This letter responds to your letter to me dated September 8, 1993. In that letter, you ask for a "hearing on the early Component Removal Project (CRP) at Yankee Rowe." However, as you note in your letter, the NRC held a public meeting near the Yankee Rowe site on June 9, 1993, at which approximately 12 NRC staff and management personnel were present to explain the decommissioning process and to answer questions by members of the public. Your letter does not identify any way in which that meeting was deficient and the NRC believes that it has taken every reasonable effort to inform members of the public of the proposed actions for decommissioning the Yankee Rowe facility.

CERTIFICATE OF COMPLIANCE
FOR RADIOACTIVE MATERIALS PACKAGES

SAFETY EVALUATION REPORT
Model No. YNPS Steam Generator Package
Certificate of Compliance No. 9256
Revision No. 0

YNPS STEAM GENERATOR PACKAGE

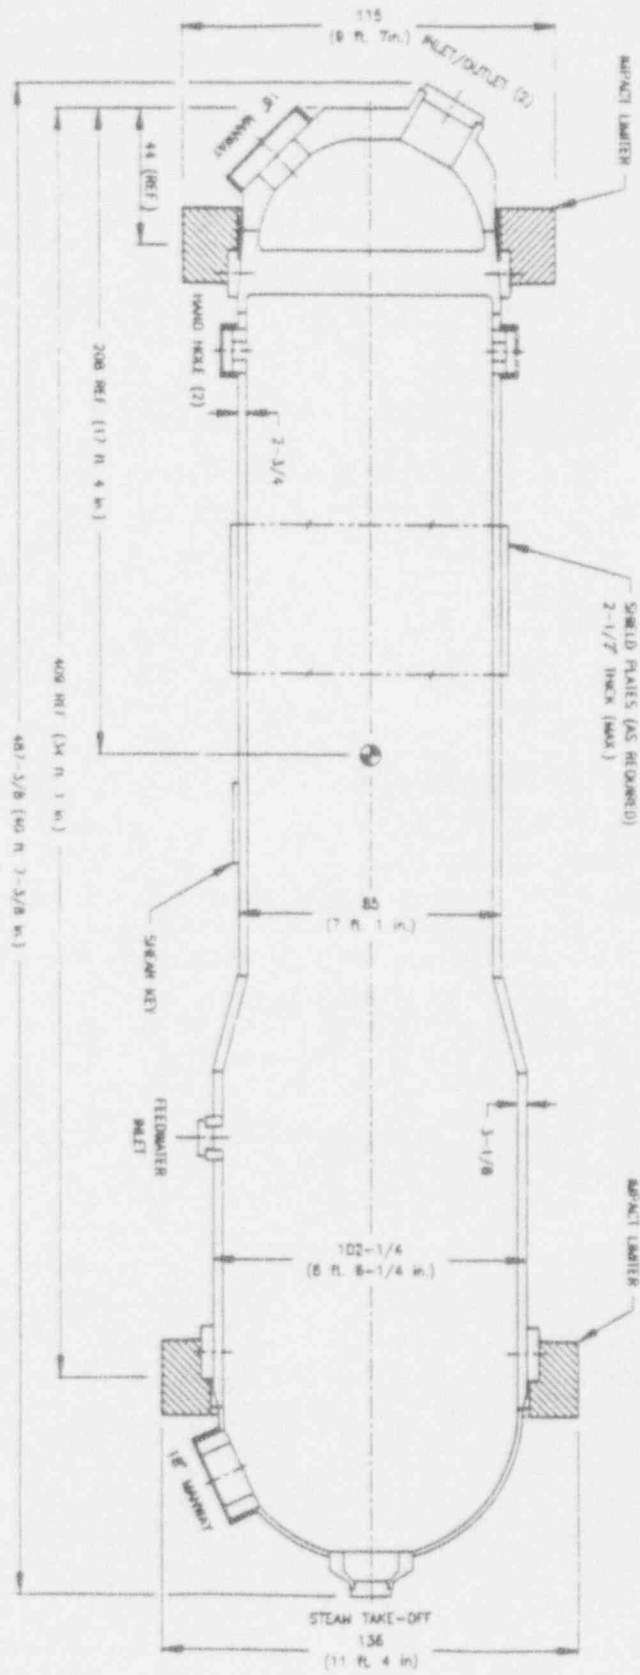
The YNPS Steam Generator package contains greater than a Type A quantity of low specific activity radioactive material. Consequently, the structural evaluation of the package must demonstrate that the design meets the performance requirements of 10 CFR Part 71 for normal conditions of transport.

The YNPS Steam Generator package has two, 12 lb/ft³ rigid polyurethane foam impact limiters to absorb the drop energy and to reduce the impact force on the steam generator. The stress-strain data for the polyurethane foam was provided by the vendor (General Plastic). To account for changes in material properties due to density and temperature variations, a ±15 percent margin was assumed to bound the response of the impact limiters.

An energy balance approach was used to estimate the amount of crush (deformation) and reaction force developed in the impact limiters during the one foot free drop onto an unyielding horizontal surface. The maximum impact limiter deformation was used to confirm that the maximum strain of the polyurethane foam was below the design limit of 70%, and to confirm that none of the steam generator penetrations would directly contact the rigid surface during the free drop. The stresses in various components of the steam generator package during the one-foot free drop event were calculated with a combination of hand calculations and finite element analyses. Stresses in the steam generator vessel shell away

from the impact region were calculated by assuming the vessel acted as a beam. A finite element analysis using ANSYS was performed to evaluate the stresses in the package at the point of impact, i.e., underneath the impact limiter. The maximum stress intensity of 16.0 ksi occurred in the steam generator shell. This stress intensity was well within the allowable stress of $1.5 S_u$ (34.95 ksi) as prescribed in Regulatory Guide 7.6. Stresses in all other components of the steam generator package were also well within the allowable design stresses. Thus, the package meets the one foot free drop condition.

The source term was used to determine the external dose rates for the package. The free space in the steam generator is filled with low density concrete, with a minimum density of 0.33F g/cm³. The tubes, low density concrete, air, and downcomer were homogenized in the computer model. The outer steel wall was modeled explicitly. The applicant used MICROSIELD to calculate the dose rates at the package surface and 2 meters. Results of the applicant's shielding analysis showed that the external dose rates at the top and bottom ends of the steam generator met the 10 CFR §71.47 external radiation standards. However, the dose rates at the surface and two meters from the conveyance exceeded the limits, without additional shielding. Shielding will be welded onto the package surface, as necessary, to meet the dose rate limits. The applicant estimated that a maximum of 2.5 inches of additional steel

The Certificate of Compliance has been conditioned to require shielding to be added to the steam generators to meet the external radiation standards of 10 CFR §71.47. The shielding is in the form of steel plates up to 2.5 inches thick welded to the steam generator shell.
